ADDENDUM No. 1

RFP No. 25-01

2025 Miscellaneous Utility Projects

SCALE PLAN: 1" = 20'
 PROFILE: 1" = 2'
 DRAWING No. **2024006-25**

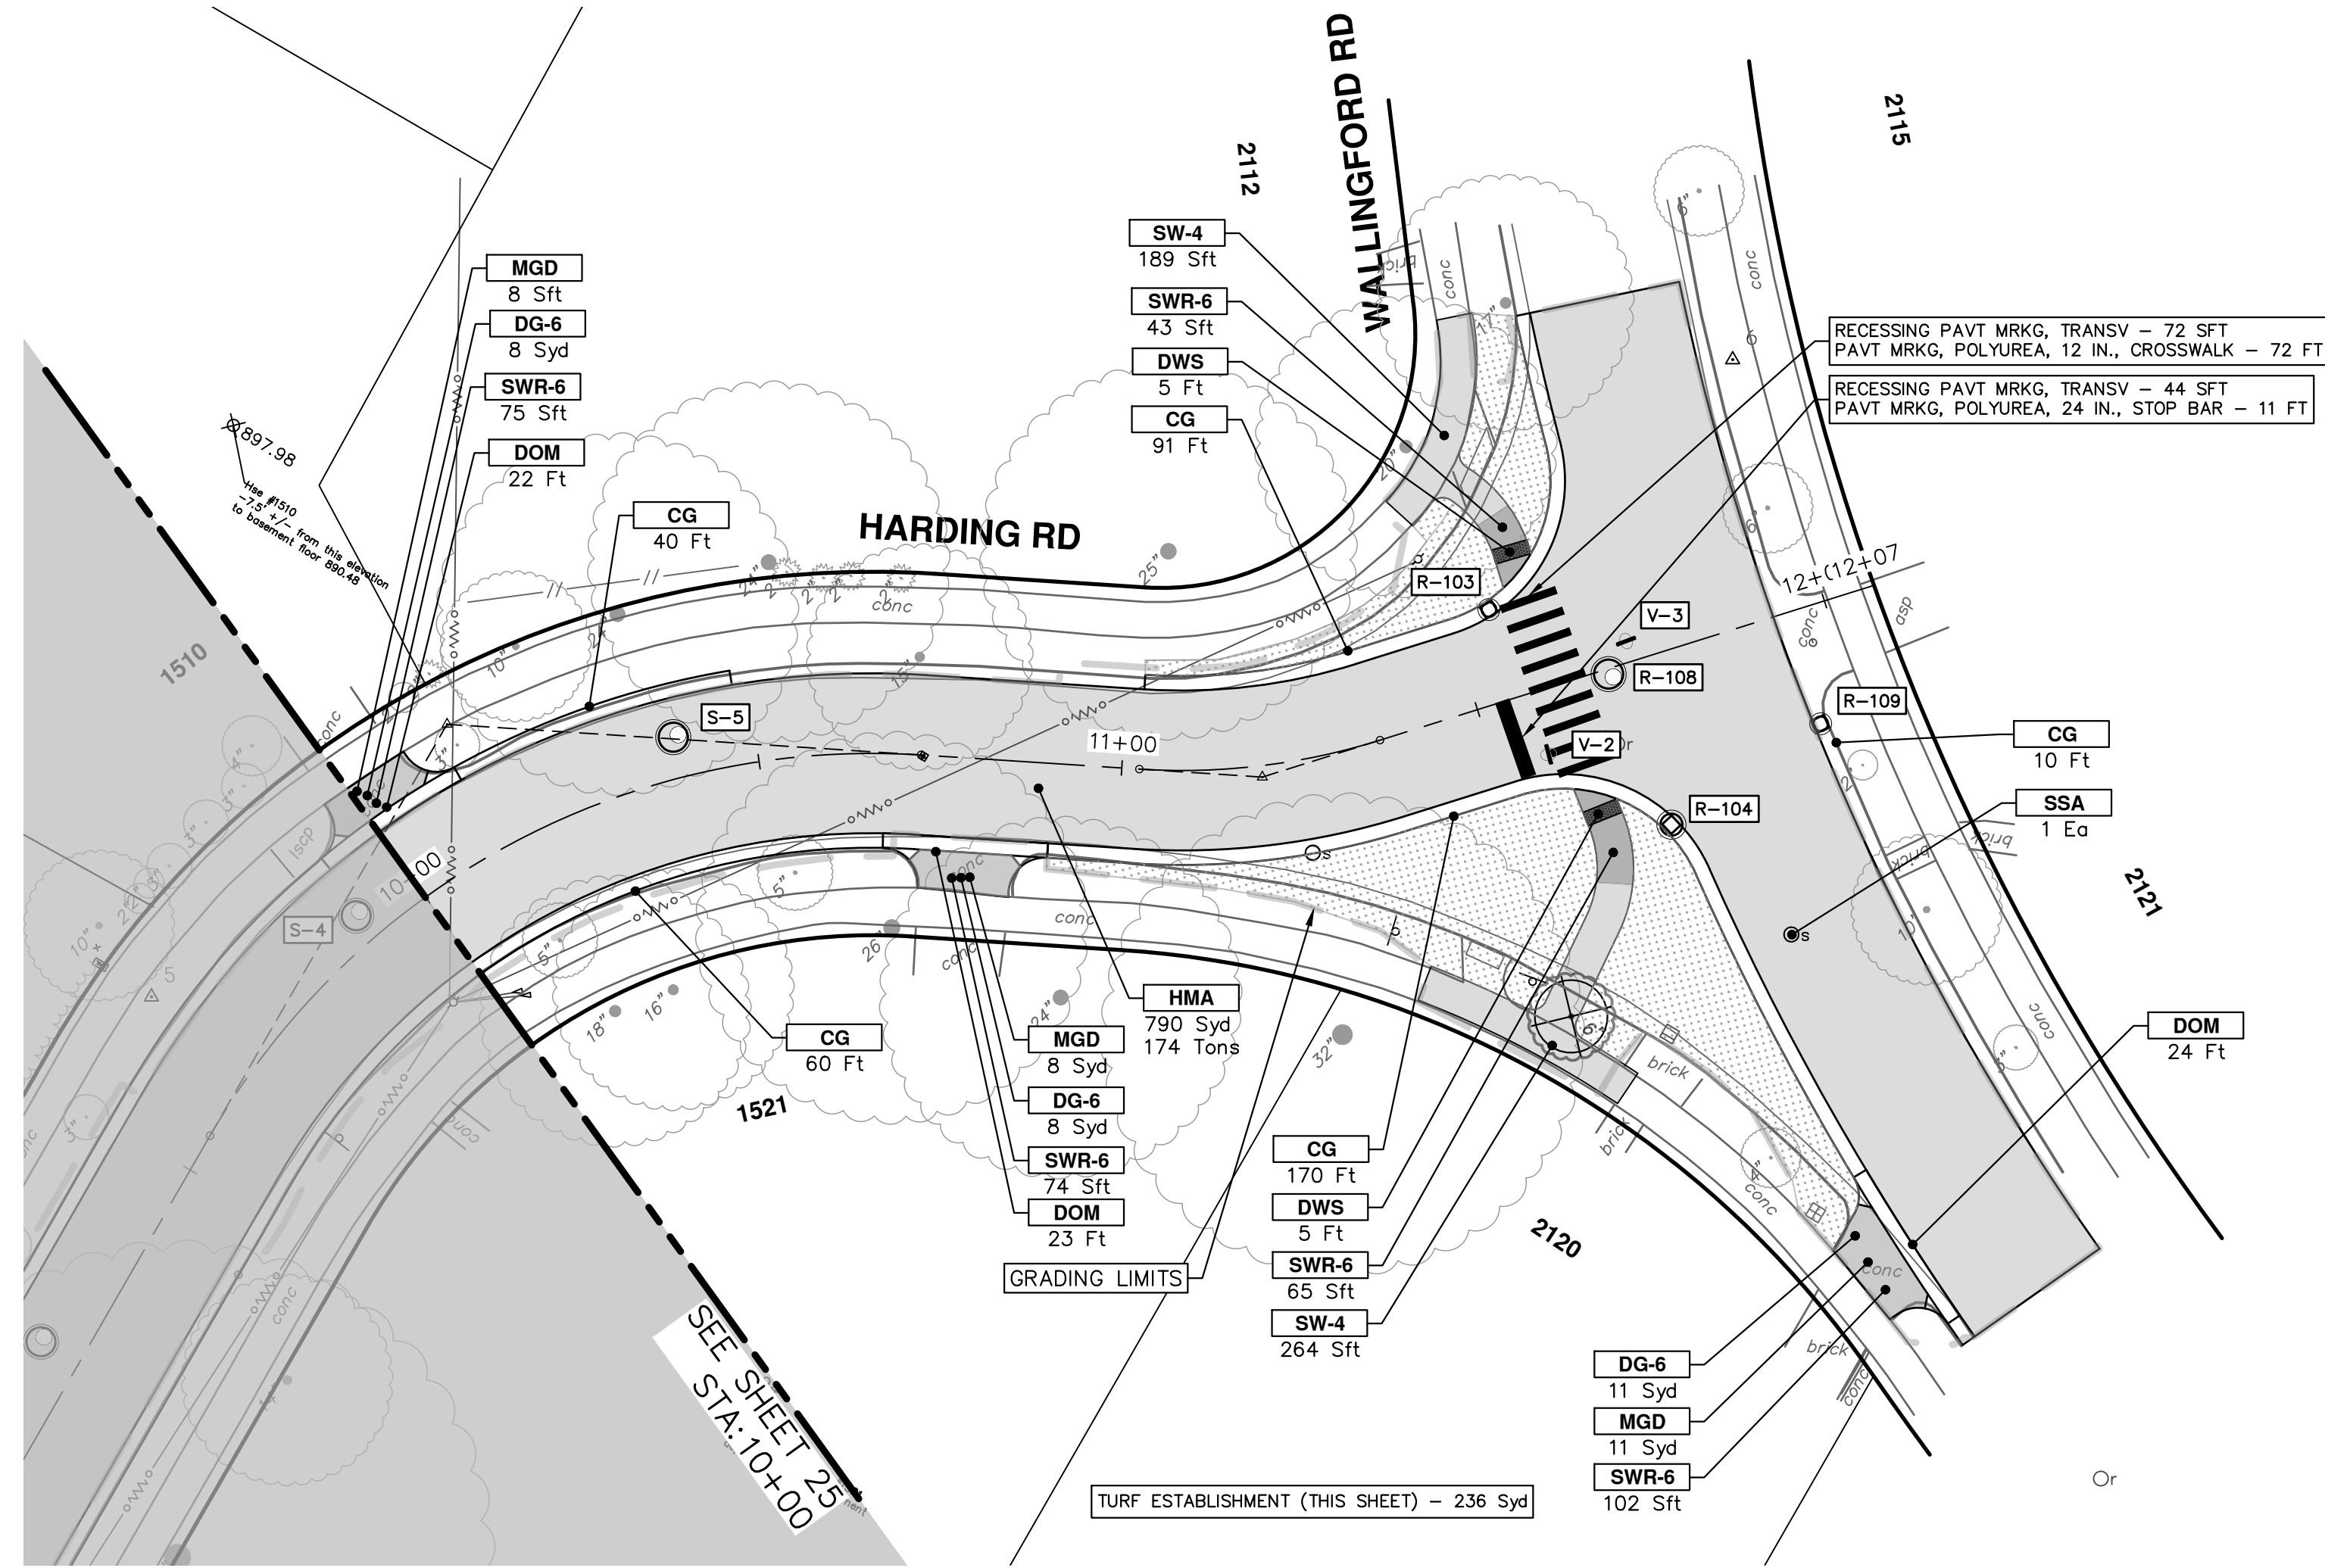
Sheet 25: Hatching removed from profile (CAD error)

SCALE PLAN: 1" = 20'
PROFILE: 1" = 2'
DRAWING NO. 2024006-40

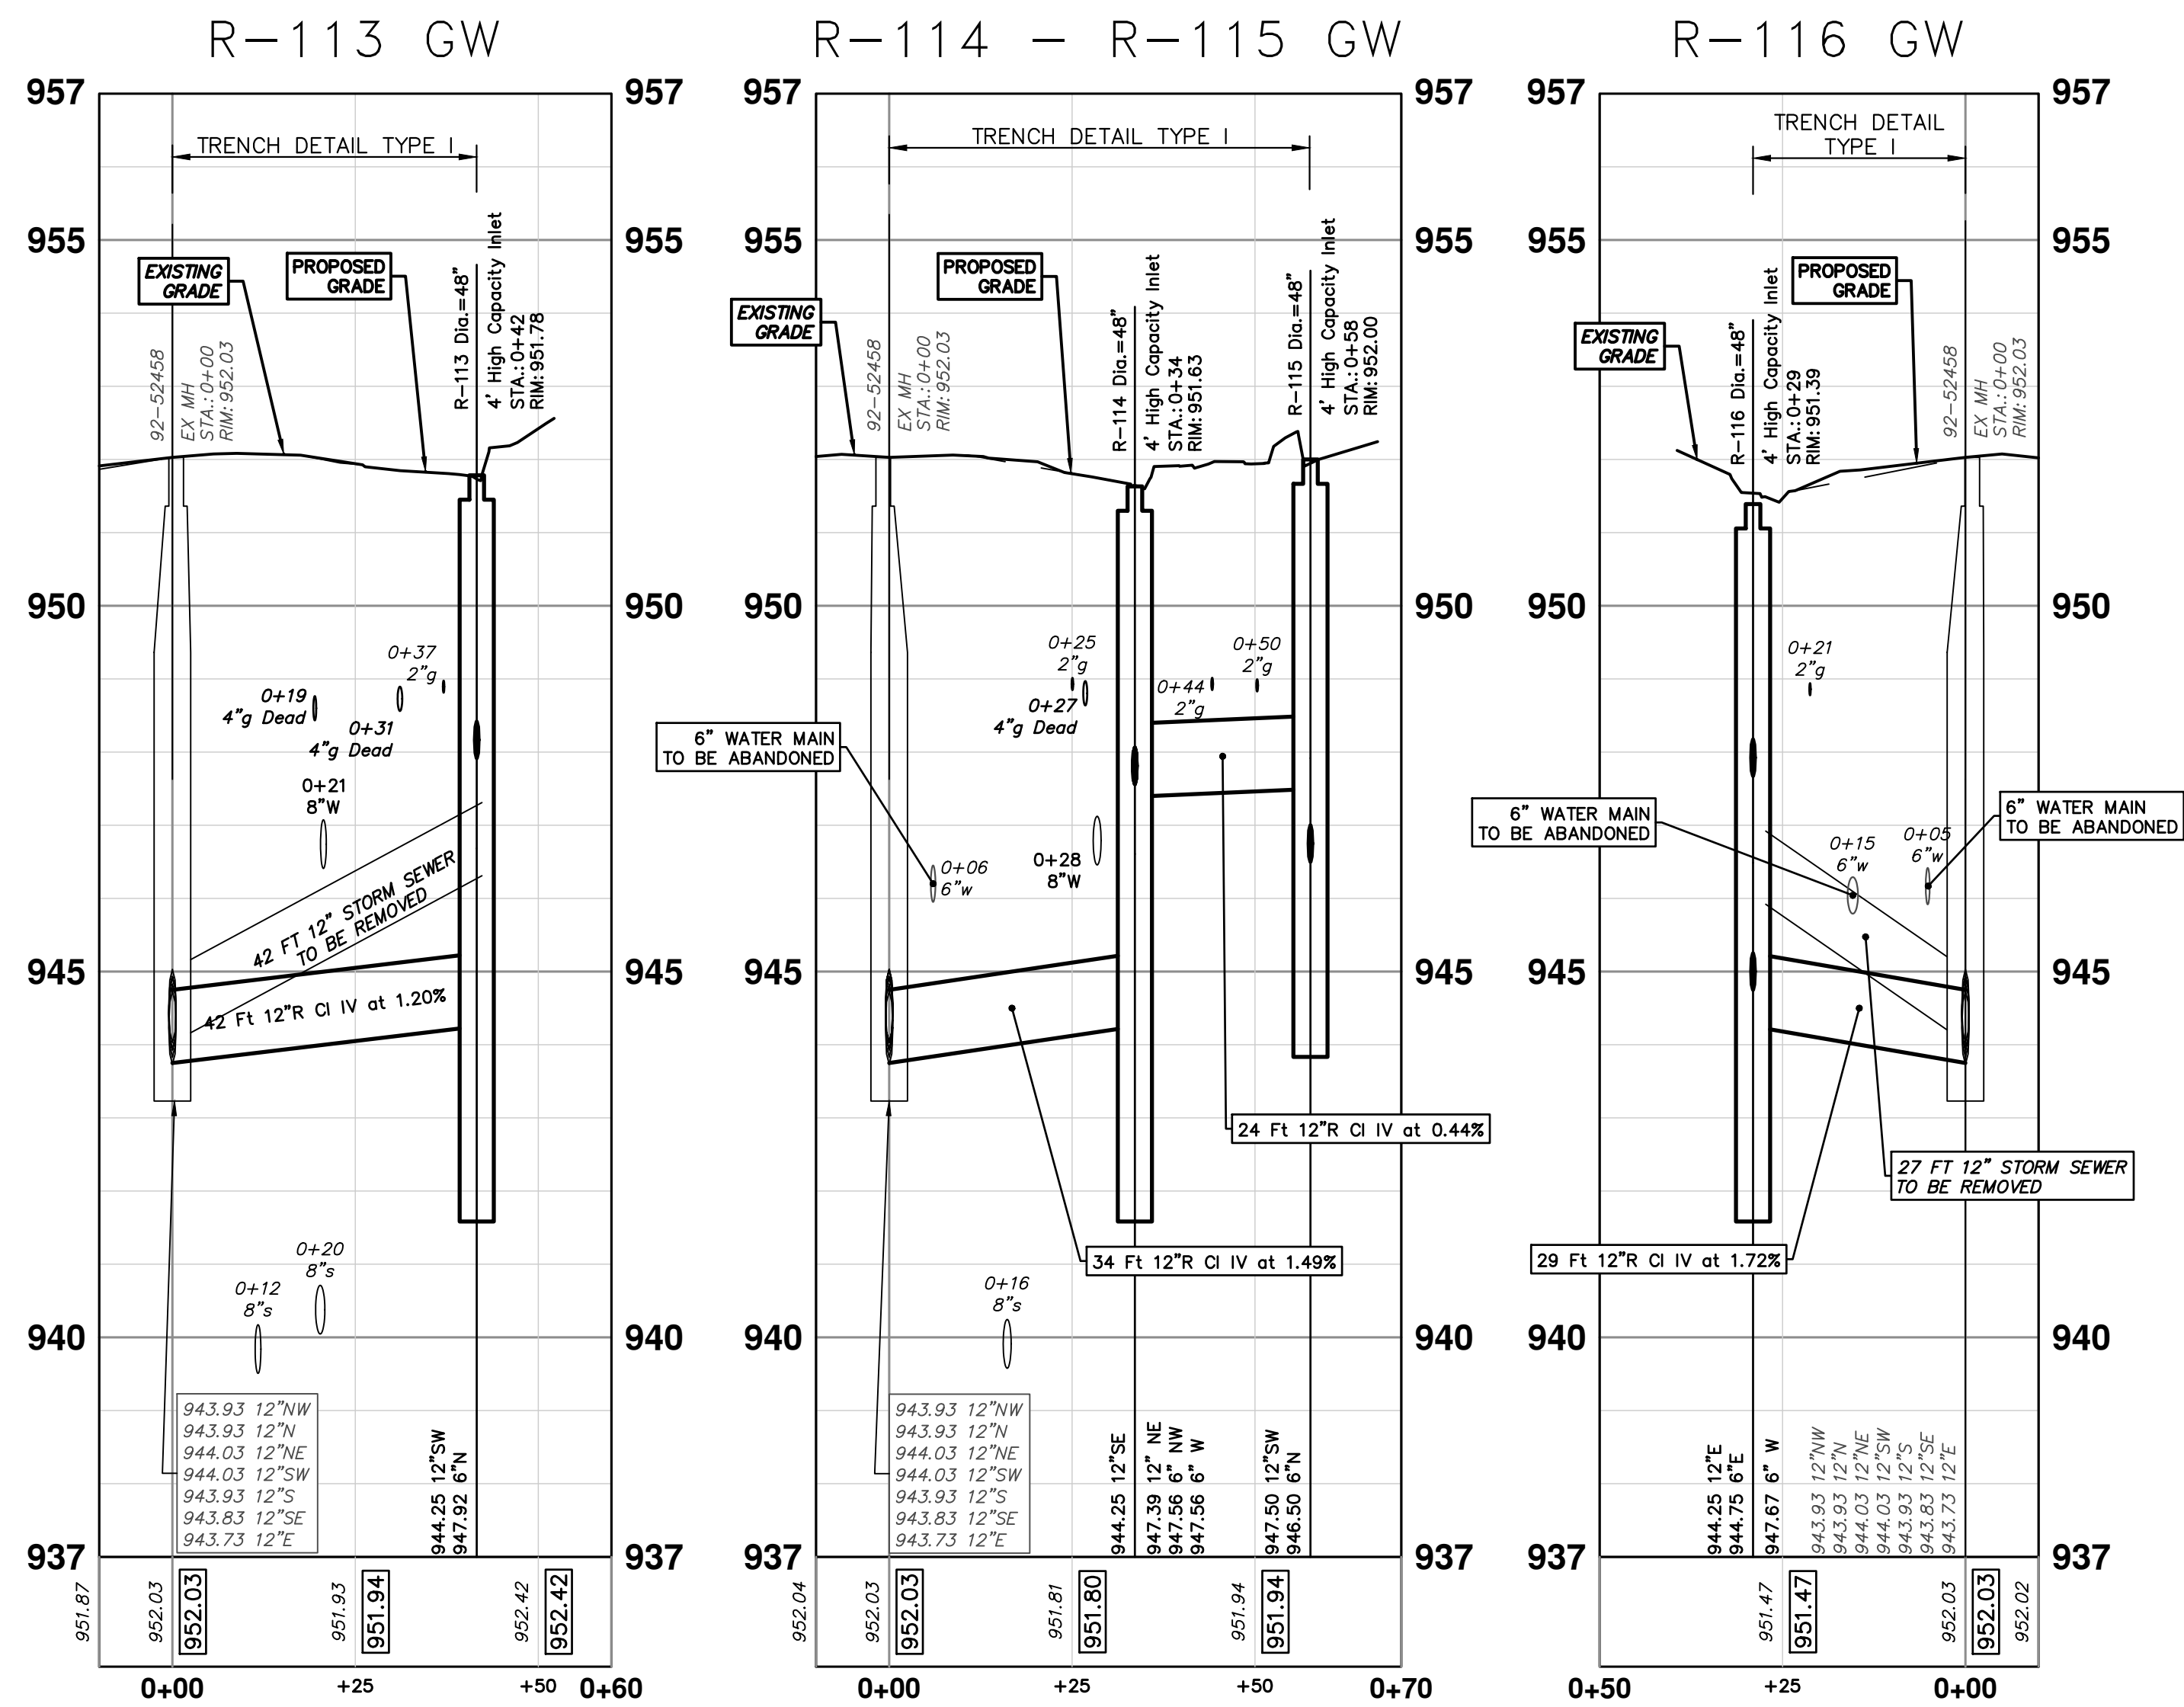
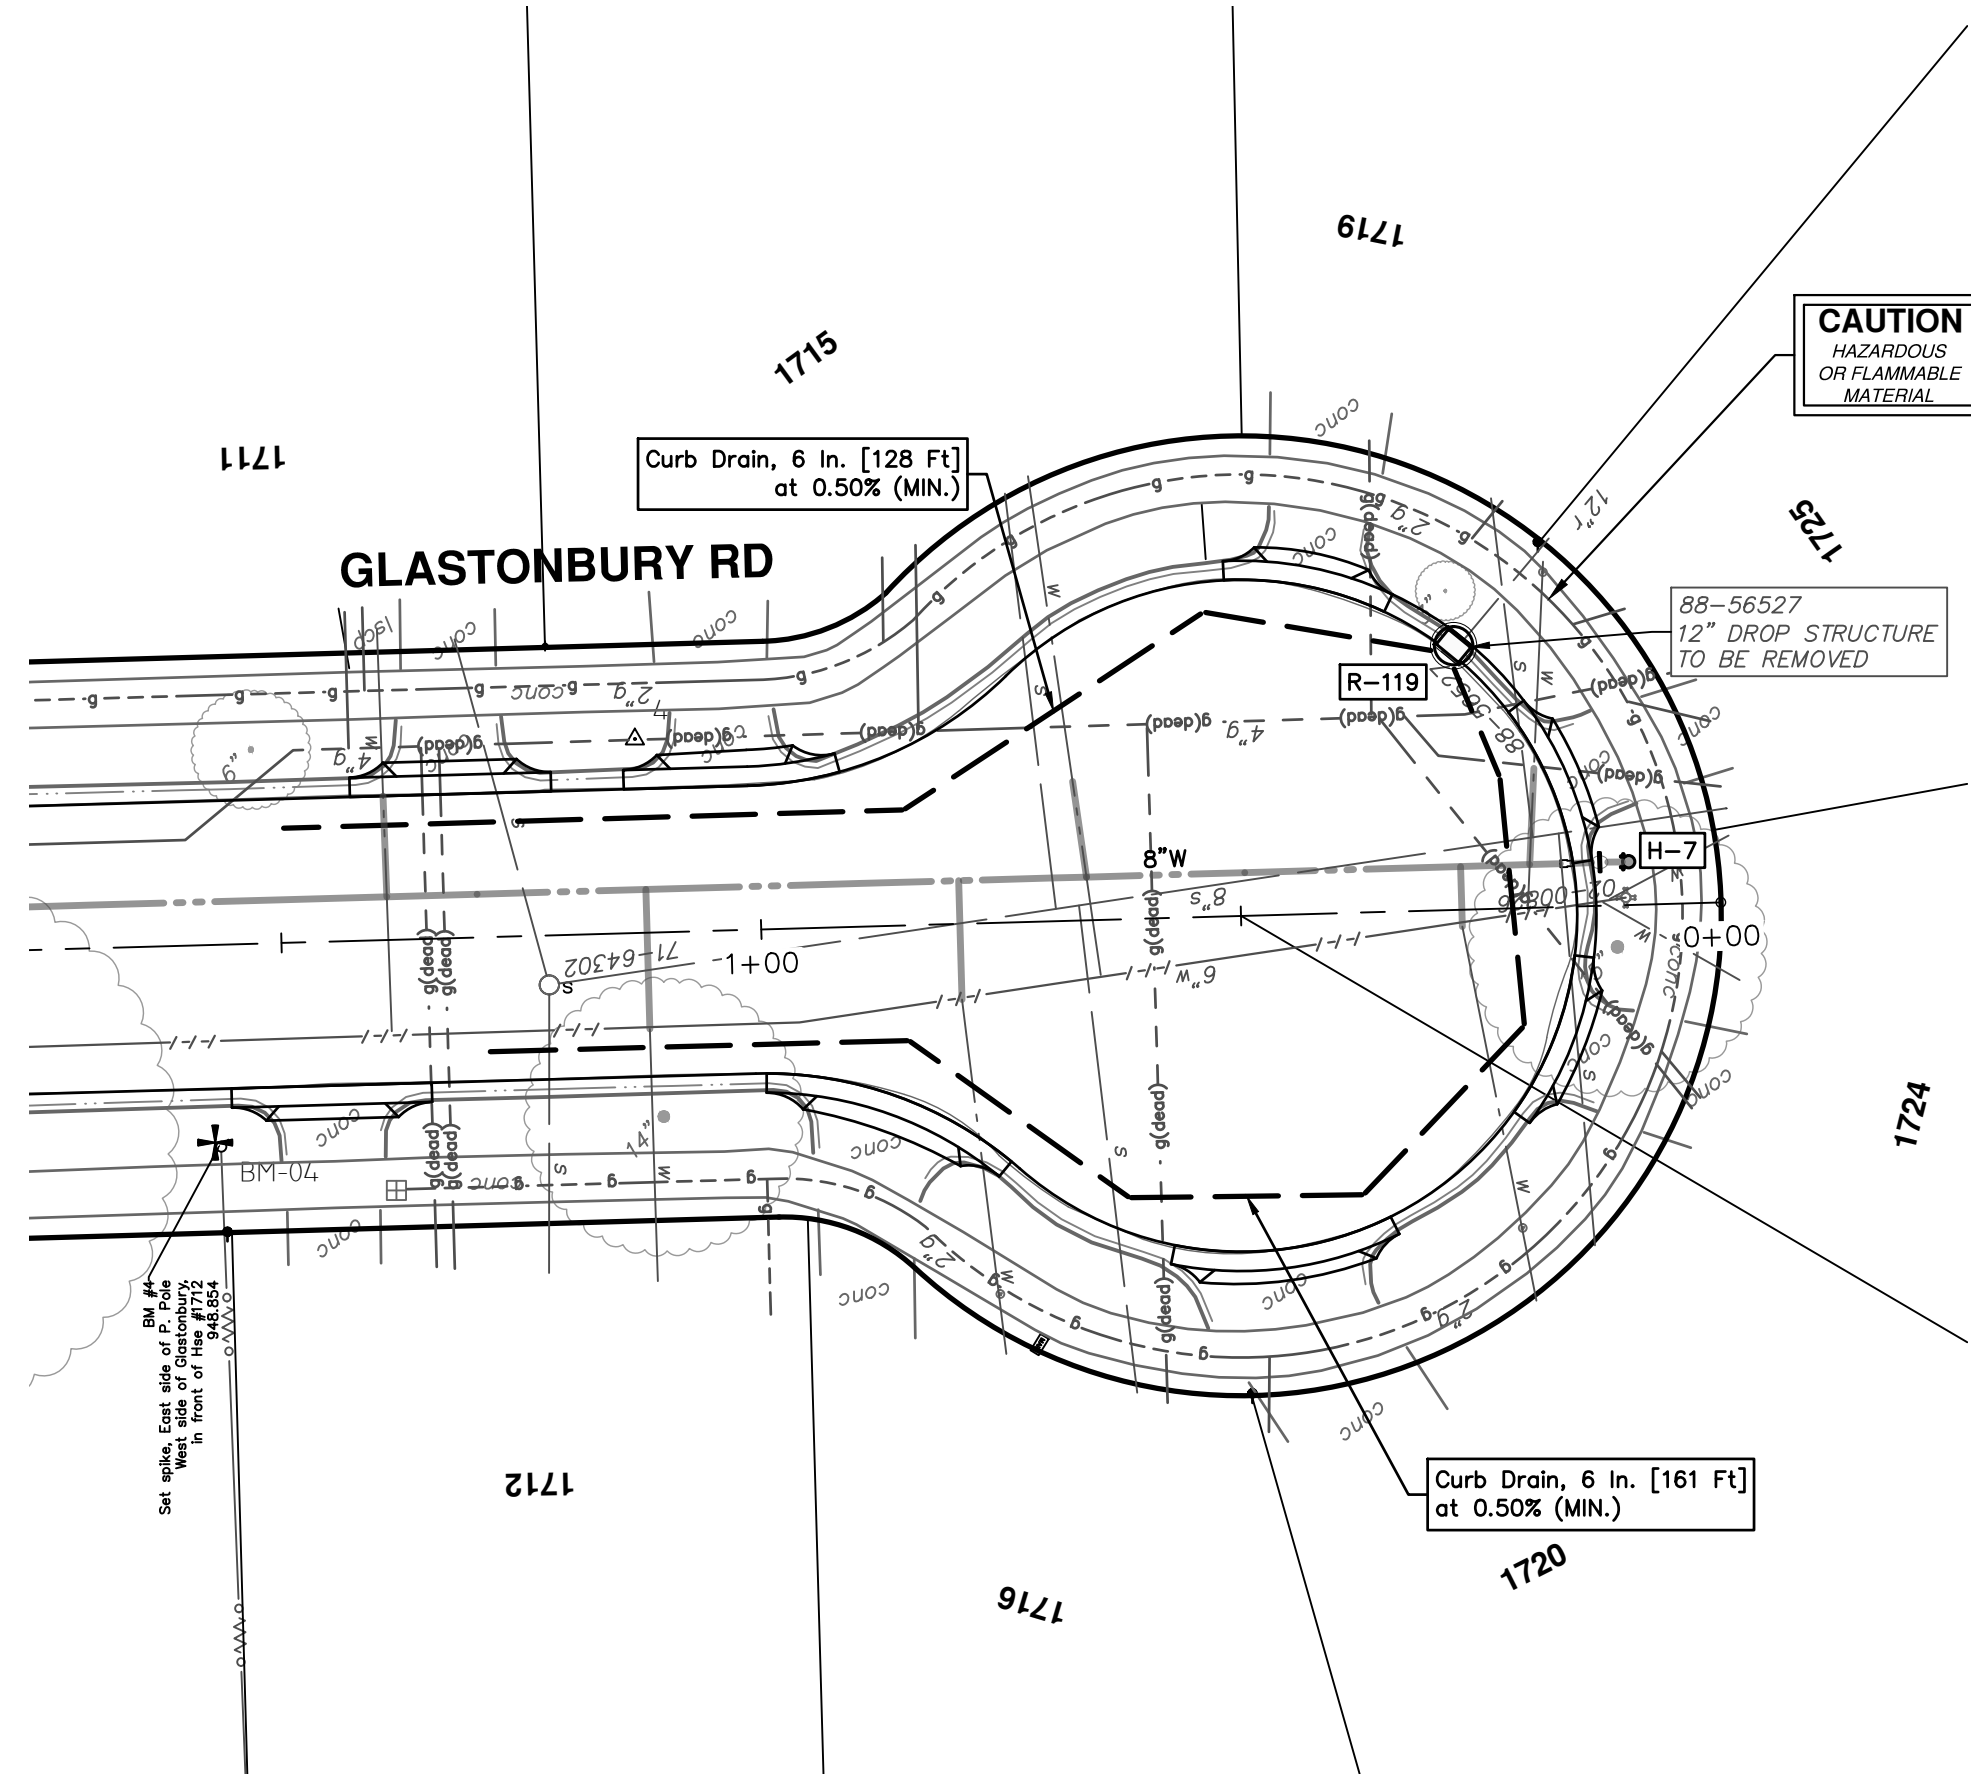
Sheet 40: R-112 and associated storm sewer removed
